MINUTES
WORCESTER TOWNSHIP PLANNING COMMISSION
WORCESTER TOWNSHIP COMMUNITY HALL
1031 VALLEY FORGE ROAD, WORCESTER, PA 19490
THURSDAY, DECEMBER 12th, 2024 - 7:00 PM

COMMERCE PURSUIT CAPITAL
TROOPER RIDGE SUBDIVISION
1035 NORTH TROOPER ROAD, WORCESTER TOWNSHIP
MONTGOMERY COUNTY, COMMONWEALTH OF PENNSYLVANIA
STORM PROFILE-1

1035 Trooper Road
MCPC#240066002

DESIGNED BY JPK/CKS/CMR/ROP/ZHR	DRAWING CSD-1
CHECKED BY BGS/ZHR	SHEET
DRAWN BY SCR/CKS/RAM	23
DATE 12/19/2024	OF 37
SCALE AS NOTED	
PROJ. NO. WDEV00004

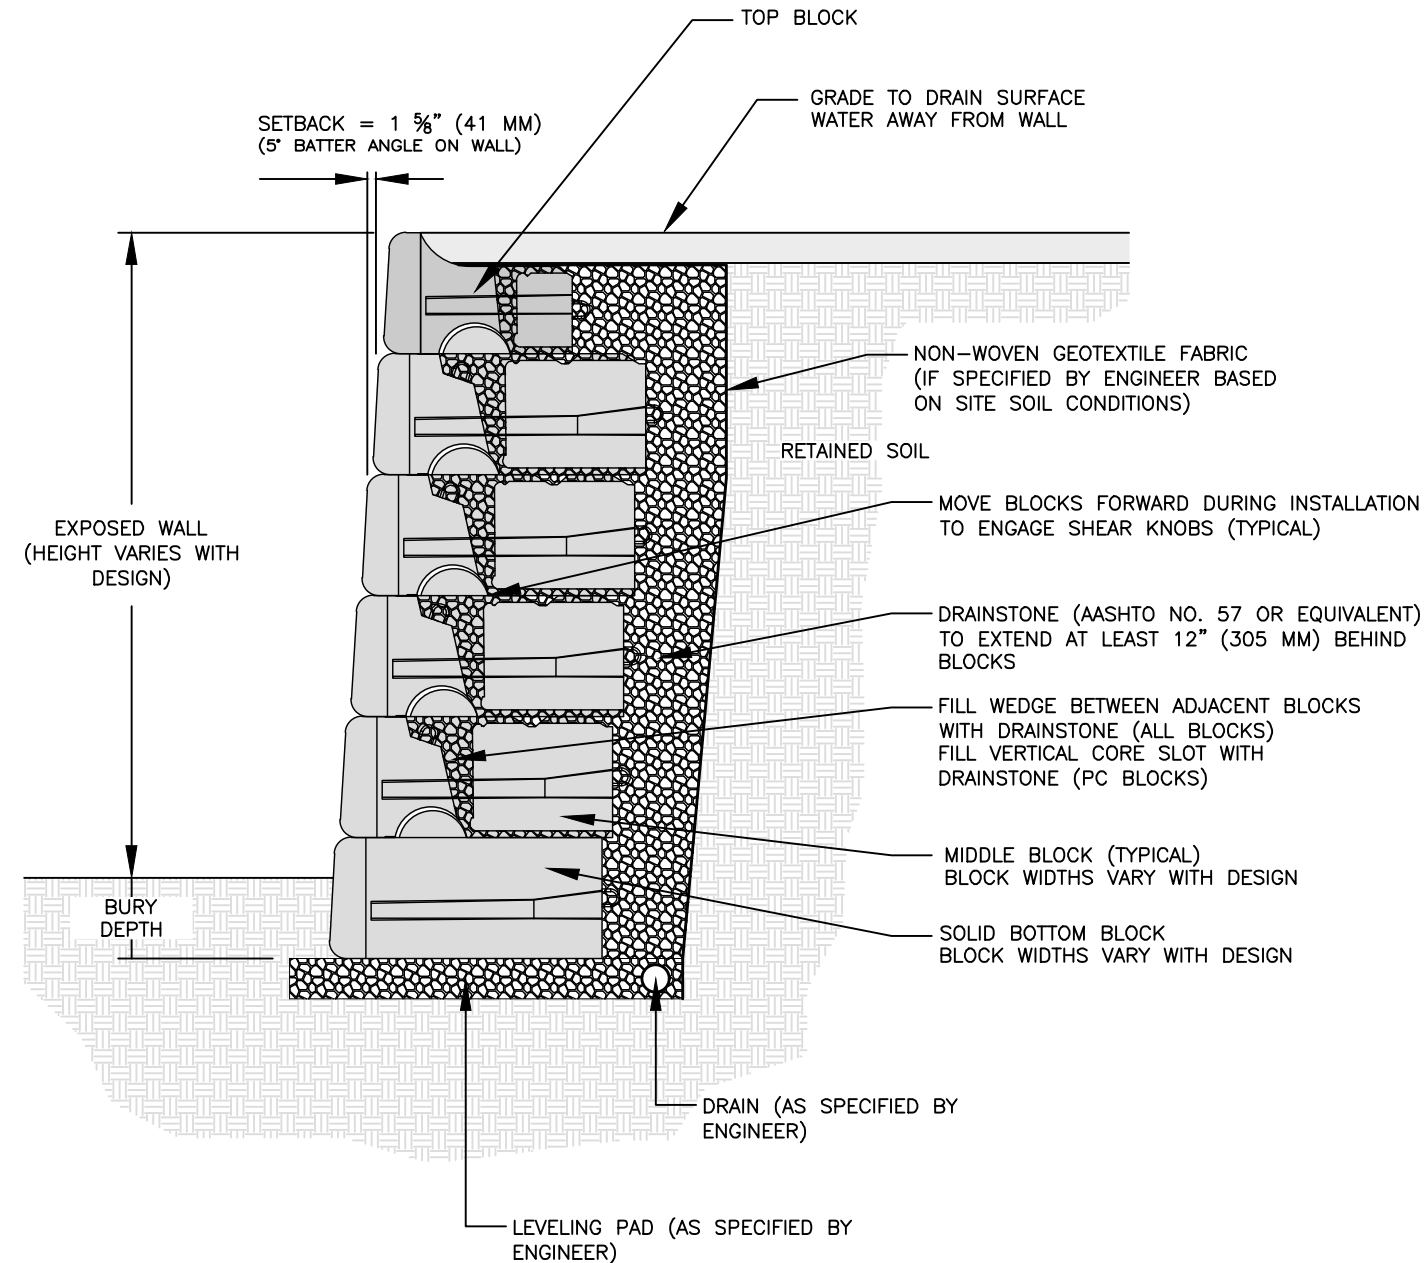
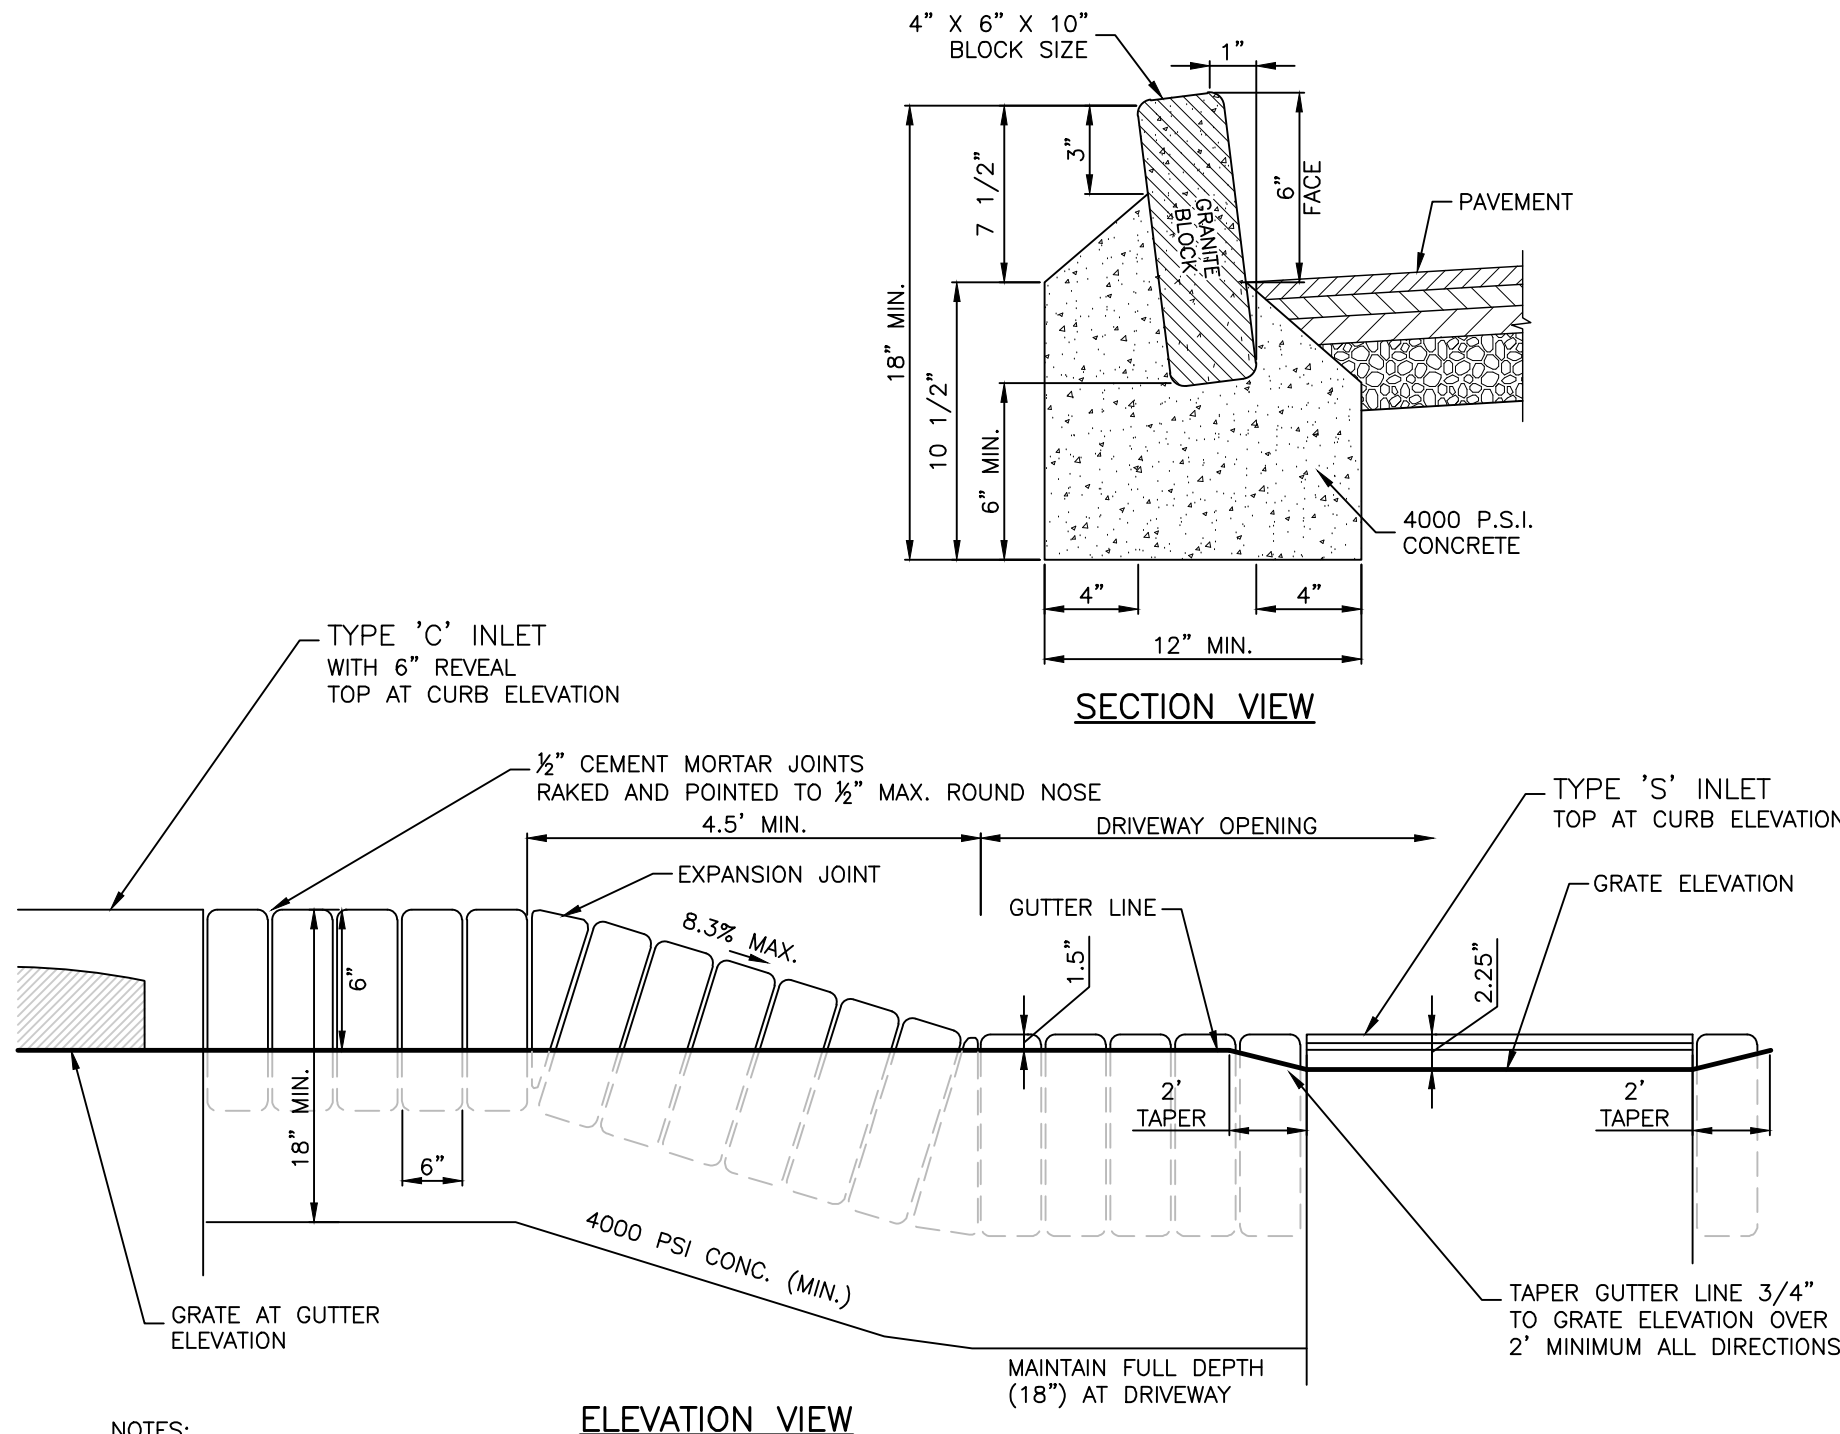
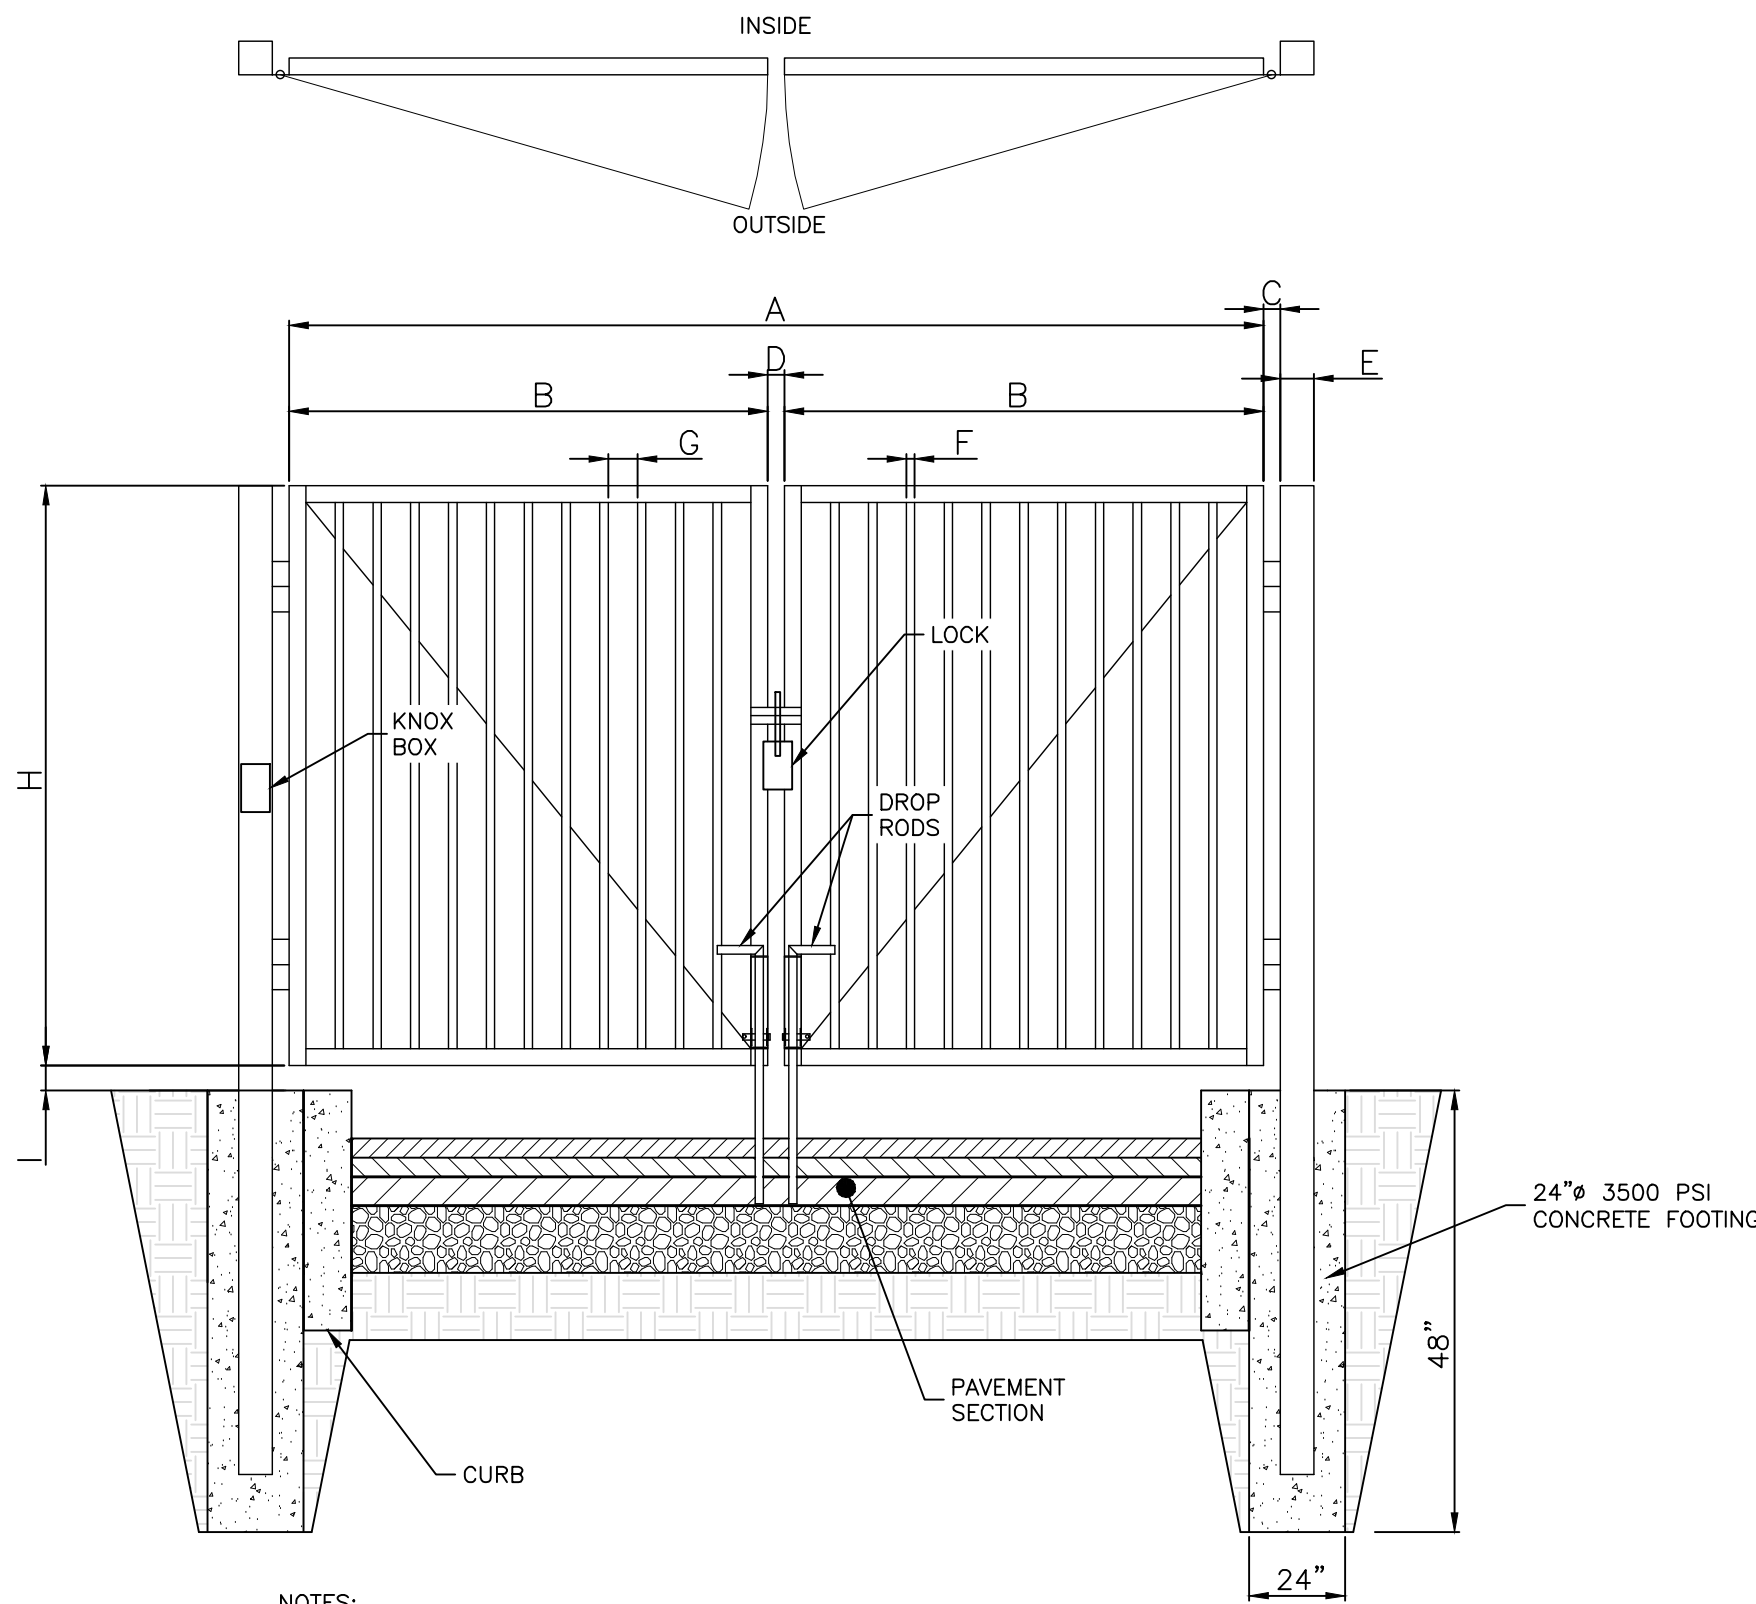
42. The designer should clarify where the detail for concrete curb on Sheet 23 of the plan set will be used.
43. The design ESALS for the proposed PennDOT pavement legend provided on Sheet 24 of the plan set should be verified.

24. The minimum required width of sidewalks, 4 feet, must be noted on Sheet 23 details. Where sidewalk is less than five feet wide, ADA compliant passing zones must be provided and may not be contained within dwelling driveways or aprons. (130-18.A0)
